Service Bulletin

Solenoid box breaker modification

All GA8 serial numbers up to S/N GA8-06-098

Document: Service Bulletin SB-GA8-2008-50

Figure 1 - Screws to be removed to gain access to internal assembly of the solenoid box

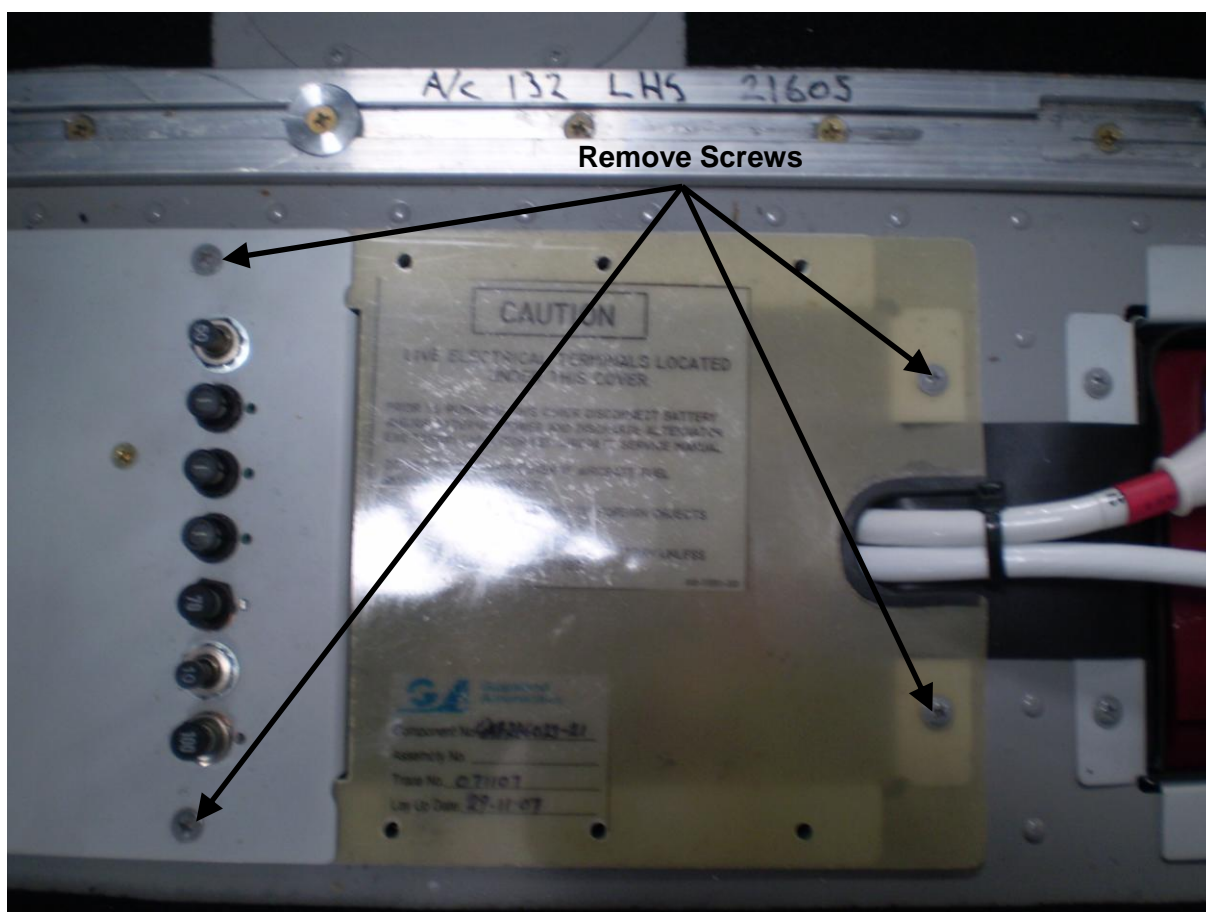
1. Remove the pilot seat and gain access to the solenoid box. Take off the fibre glass battery cover.
2. Gain access to the battery box. Disconnect the positive terminal connected to the battery from the aircraft as a precautionary measure. Refer to the GA8 Service Manual Section Chapter 24.
3. Gain access to the internal components of solenoid box by removal of screws as noted in Figure 1. Take care not to damage the heads of the screws when undoing them. Remove the fibre glass sheet. Refer to the GA8 Service Manual Section Chapter 24 taking specific note of the warning in Section 24-00-00.

Figure 2 - Showing the first two wires to be disconnected

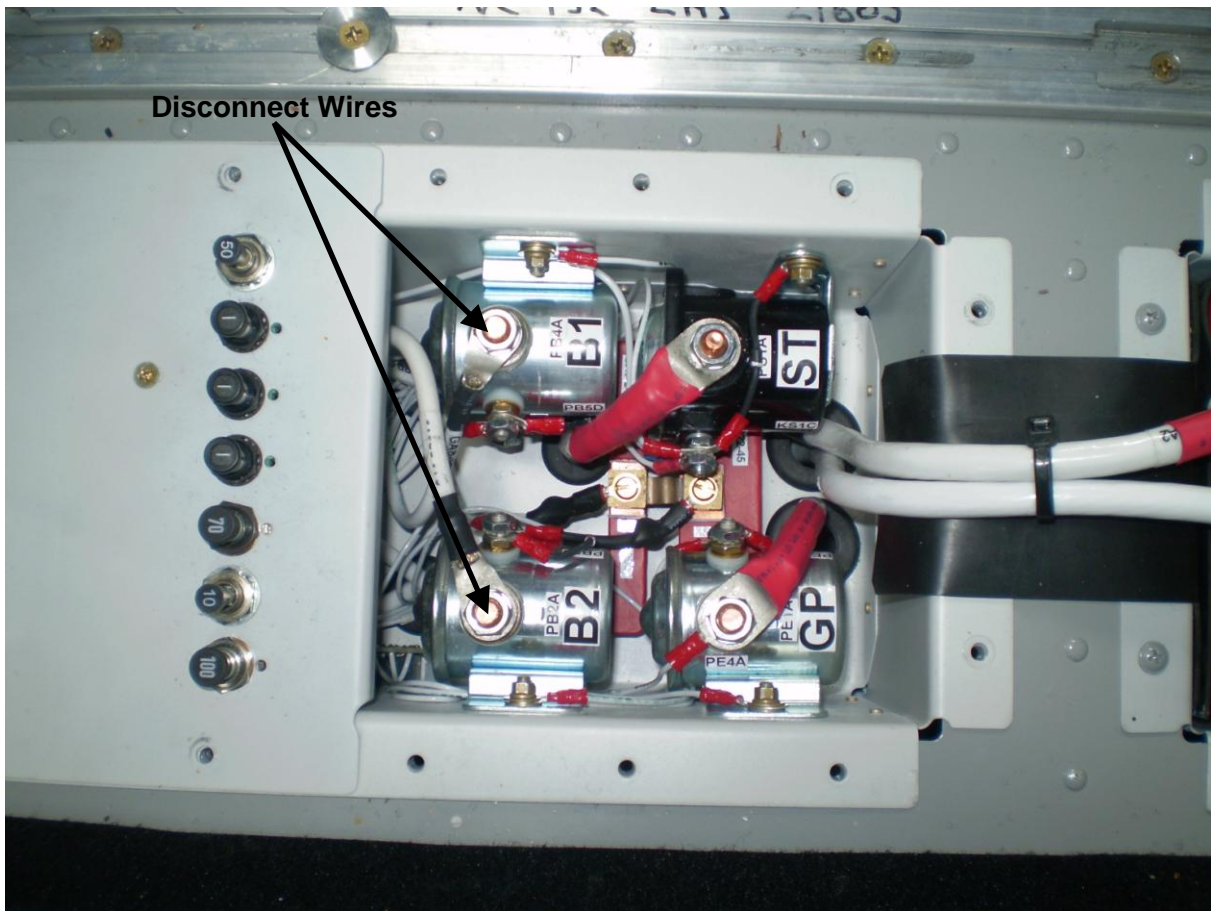
- Gain access to the Circuit Breaker Assembly and remove this from the main solenoid box assembly. This will require disconnecting of wires PB4A8, PB4B8, PB2A6, PB2B6 to ease the modification of the circuit breaker panel. Refer to Figure 2. Remove the existing 1A breakers from the assembly and discard. Retain the bus bar (GA8-311022-33) for reinstallation.

Figure 3 - Modification to Breaker Panel, viewed from above when fitted into aircraft

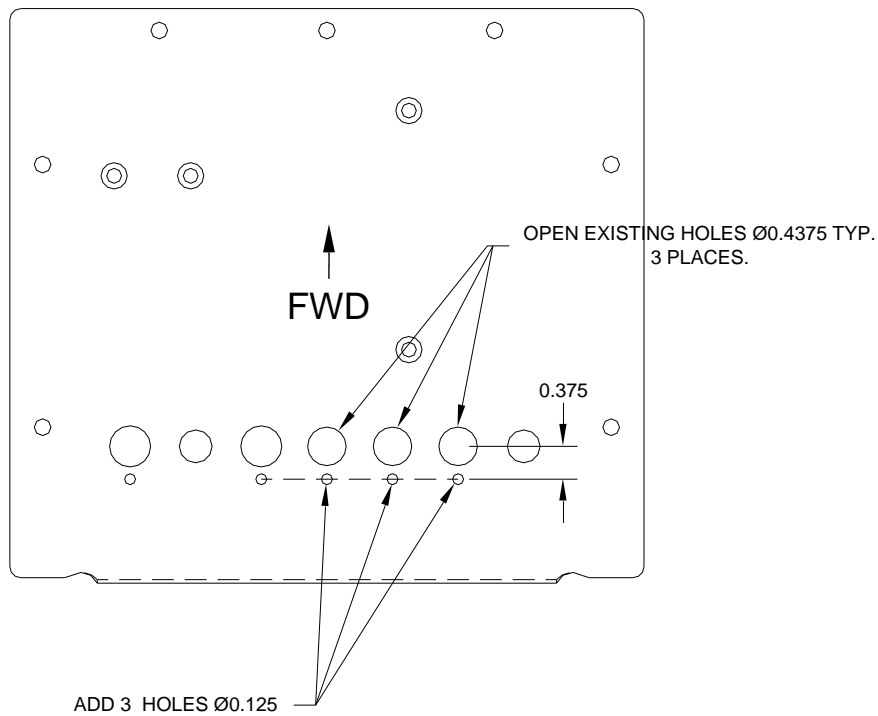
5. Modify the Breaker Panel as detailed in Figure 3. Each new breaker requires the existing mounting hole to be enlarged to 0.4375 inches diameter and the addition of a 0.125 inch diameter hole per location. Remove all swarf.

Figure 5 - Partial wiring schematic showing underfloor circuit breakers.

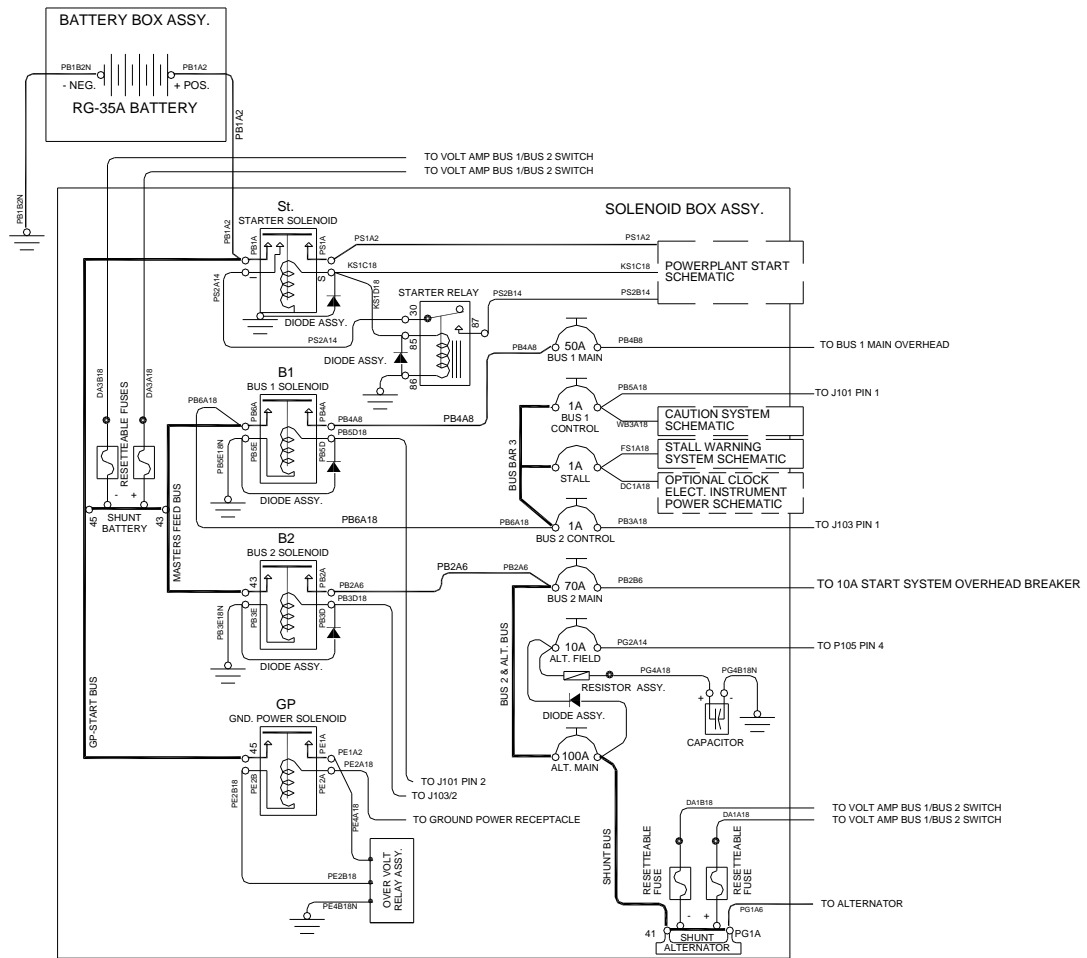
- Refit the Circuit Breaker Assembly to the solenoid box. Refer to Figure 5 for the wiring to circuit breakers. Refer also to Chapter 24, Figure 24-1 of the Service Manual
